HISTORIC AND DESIGN REVIEW COMMISSION

October 18, 2017

HDRC CASE NO: 2017-483
ADDRESS: 309 PIERCE
LEGAL DESCRIPTION: NCB 1276 BLK 8 LOT 14 PIERCE DUPLEX SUBD
ZONING: R-5 H
CITY COUNCIL DIST.: 2
DISTRICT: Government Hill Historic District
APPLICANT: Nicole Garza
OWNER: Adrienne Davis
TYPE OF WORK: Final approval for new construction of 2-story single family home
REQUEST:

The applicant is requesting a Certificate of Appropriateness for approval to construct a 2-story single family residence at the vacant lot at 309 Pierce.

SOUTH ELEVATION

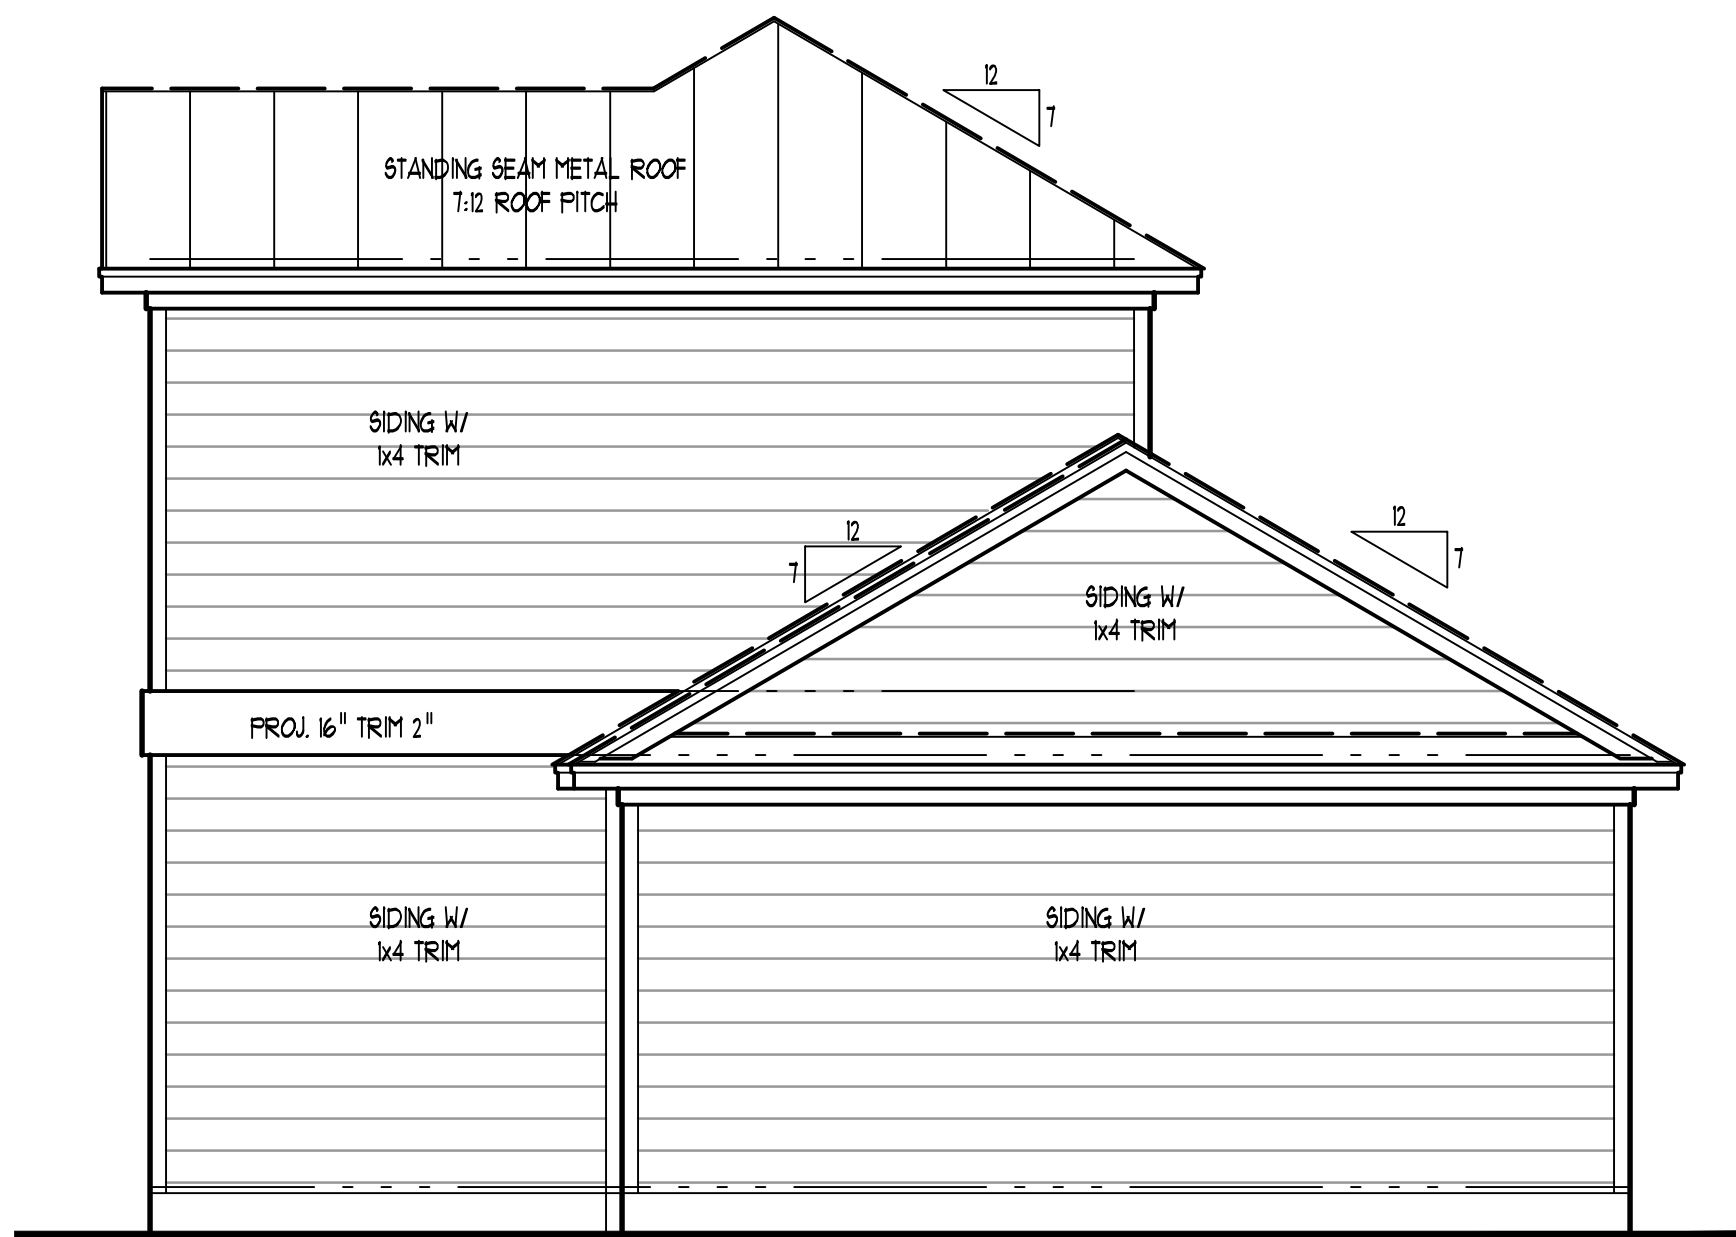
- e. ORIENTATION – The applicant has proposed to orient the structure towards Pierce. According to the Guidelines for New Construction, the front façade should be oriented to be consistent with those historically found along the street frontage. The adjacent single family homes orient towards the Interstate 35 Frontage Road. Staff finds the primary orientation inconsistent with the Guidelines.

- g. SCALE – The applicant has proposed a 2-story single family structure. Per the submitted elevations, the ridgeline of the highest point appears to measure approximately 24 feet in height. Guideline 2.A.i stipulates that the height and scale of new construction should be consistent with nearby historic buildings and should not

- i. **ROOF FORM** – The Historic Design Guidelines for New Construction state that new structures should incorporate roof forms, including pitch, overhangs, and orientation, that are consistent with those predominantly found on the block. The applicant has proposed an overall hipped roof form that is reflective of historic homes in the area with smaller gable roofs. Staff finds the proposal generally consistent with the Guidelines.

1. That the applicant orients the primary entrance of the structure towards Interstate 35 Frontage Road to be more consistent with the development pattern of the block as noted in finding f.
